# CAMPBELL SUBDIVISION W/MODIFICATION OF STANDARDS

## SUMMARY

# PROJECT ANALYSIS

## PROPOSED DEVELOPMENT PLAN

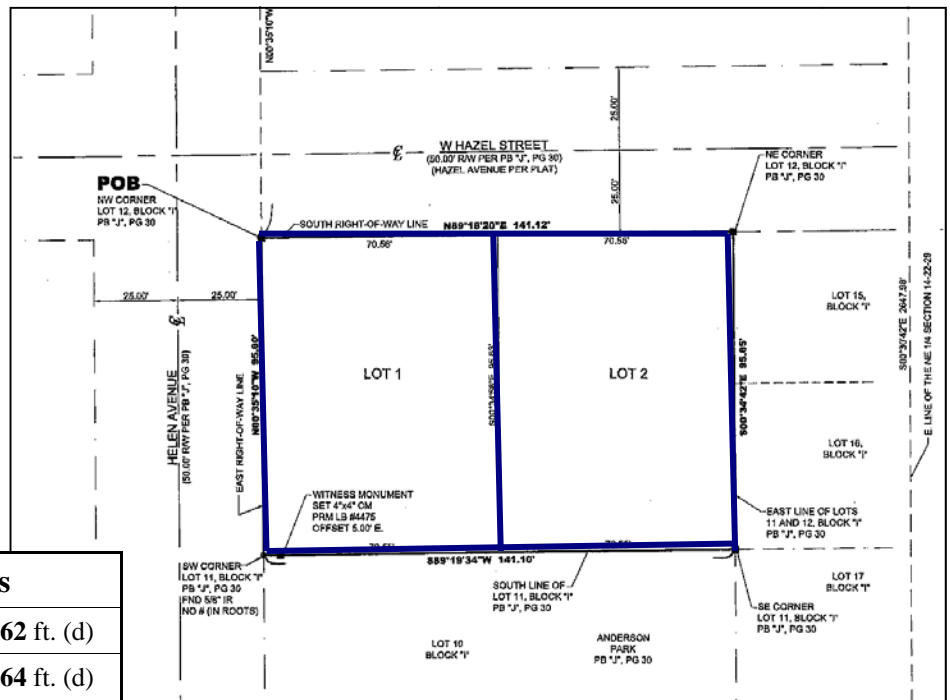
Via the Replat with Modification of Standards process (LDC Section 65.452), the applicant seeks to divide the property into two nearly equal parcels, at 70.56 ft. wide x 95.6 ft. deep (6,747 sq. ft.), where the minimum required 110-ft. lot depth will not be met.

Staff looked at the prevailing development pattern along the W. Hazel St. block face (north and south sides, between Helen Ave. and 2 lots east of Oberlin Ave. (see Table 3 below and map on page 5) and determined that building living area and FARs were considerably lower than the maximum allowed 0.50 FAR and lower than the applicant's proposed average 1,687 sq. ft. of living area and average 0.25 FAR. The applicant has provided the required development plan and building elevations for the two (2) new homes (pages 7-8).

1. Maximum FAR - In order for the proposed houses to “blend” with the existing neighborhood development pattern, the maximum living area of the houses, as provided in this report, shall not exceed 1,750 sq. ft. living area (FAR of 0.26).
2. Nonconforming Lots - The attached garages for both units shall be recessed at least 5 ft., in accordance with LDC Section 58.1152.
3. Consistency with Staff Report - Building permits shall match the development plan and building elevations for the two (2) new homes provided in this staff report. Modifications to the site plan not meeting Code shall require approval of a variance prior to permitting.

# PROPOSED BUILDING ELEVATIONS

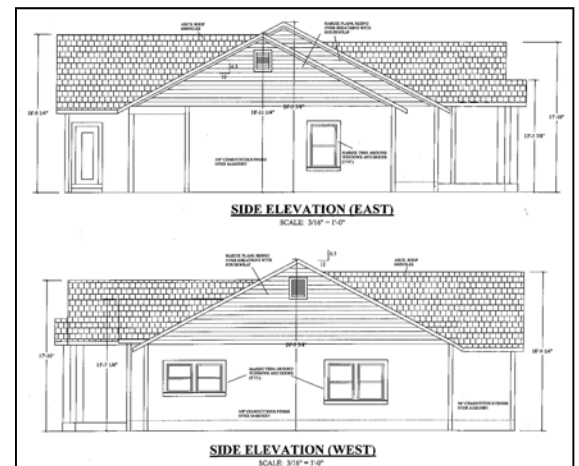
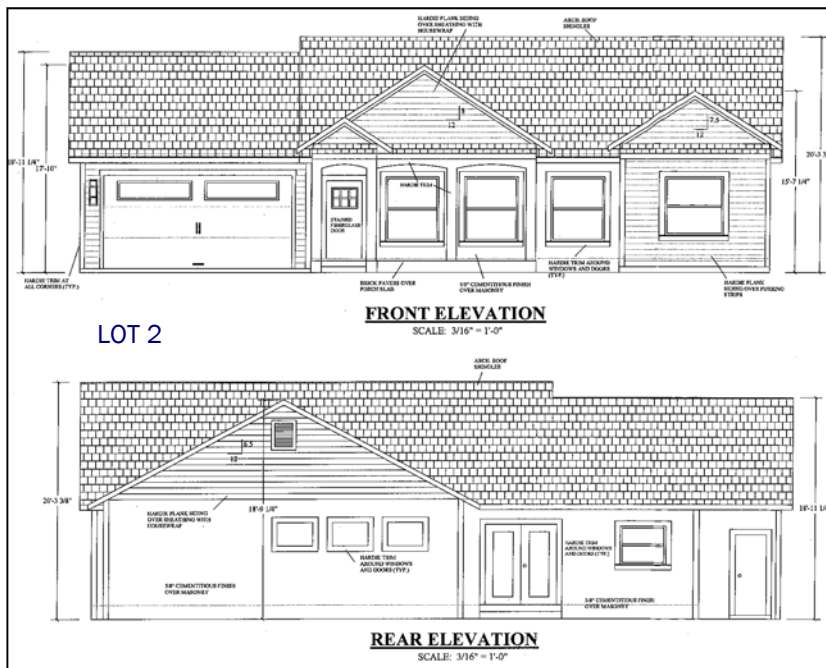
- Height.** The maximum building height shall be two (2) -stories. **Proposed homes will be 1-story in height.**
- Floor Area Ratio (FAR).** The maximum floor area ratio shall be 0.50. **Proposed FARs will be 0.25 & 0.26, respectively.**

bined width of all garage door(s) facing a street shall not exceed thirty-five percent (35%) of the combined width of all building elevations facing a street, including the garage accessory structure. **Garages will need to be recessed 5 ft. from the building façade.**
